**RE: RESPONSE TO SUBMISSIONS - CROOKWELL 3 WIND FARM (SSD 6695)**

### **Crookwell 3 Wind Farm – Response to Submissions – Addendum EIS**

### **Crookwell 3 Wind Farm (SSD 6695) Comment on the Response to Submissions**

**Re: Crookwell 3 Wind Farm – SSD 6695 – Response To Submissions**

Map 1

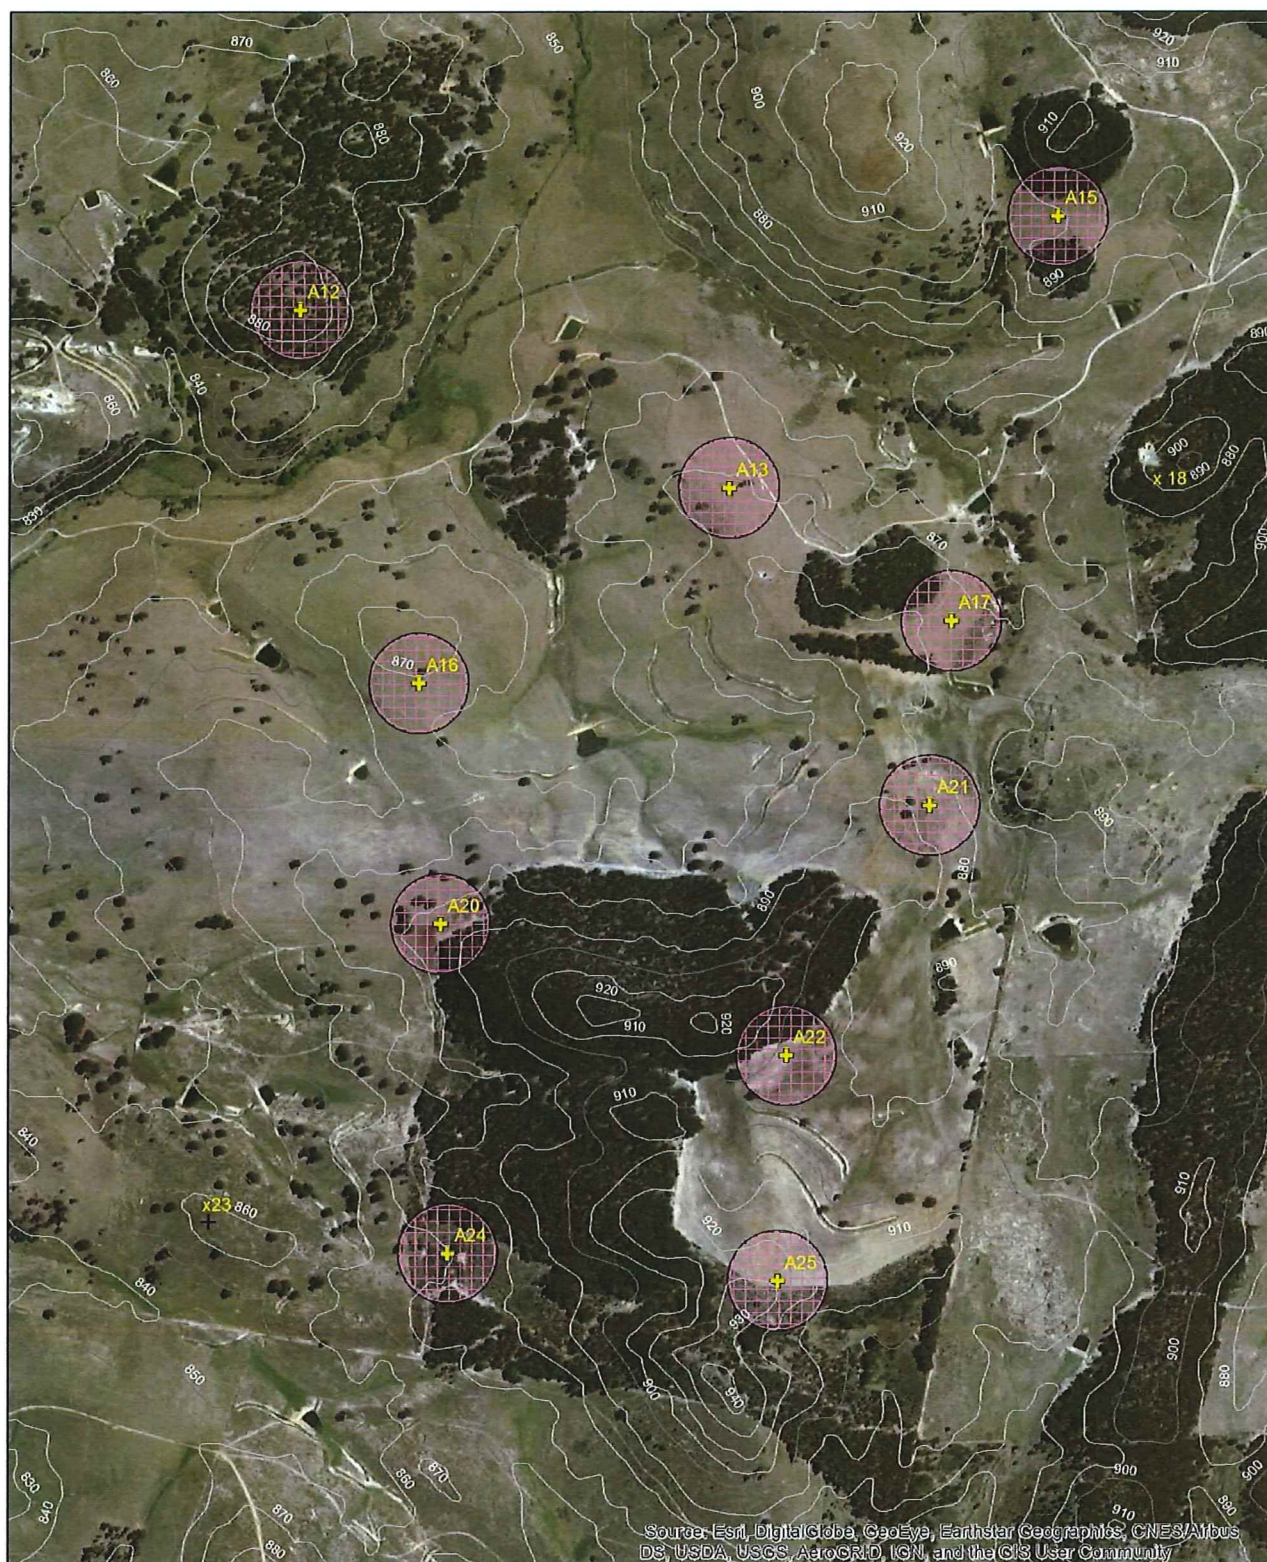
At Crookwell 3 Wind Farm, the risk would be minimised by ensuring a distance of at least 82.6m between turbines and remnant woodland. The attached **Map 1** shows that some turbines are too close to woodland, as indicated by buffers of 82.6m (pink) and 87m (black). Buffers correspond to approximate height of the vegetation of 15m and 20m (as described in Attachment 1). There are also ecological implications of locating turbines surrounding remnant vegetation, particularly if the woodland is at a higher elevation. These turbines present the highest risk of collision, as fauna flying out of the canopy on the hilltops will be at RSA.

The attached **Map 1** shows the location of some of the turbines at Crookwell 3 Wind Farm, with buffers of 82.6m (pink) and 87m (black) – corresponding to approximate height of the vegetation of 15m and 20m (as above). Clearly several turbines are much closer than the recommended distance from remnant woodland edges. These areas present a high risk of collision for birds and bats.

The turbines to be used at Crookwell 3 have blades of 65m or a RSA diameter of 130m. The location of turbines A20, A22, A24 and A25 surrounding remnant hilltop forest increase the risk to birds and bats. Fauna flying out of the canopy on the hilltops will be at RSA. Map 1 shows the 10m contour lines to clarify this. Turbine A15 is also located at a low point between two small remnant patches of forest, posing a high risk to birds and bats. It is possible that the collision risk could be reduced by micro-siting turbines A15, A17, A20, A22, A24, A25 further from the vegetation and adhering to the recommended buffer distance.
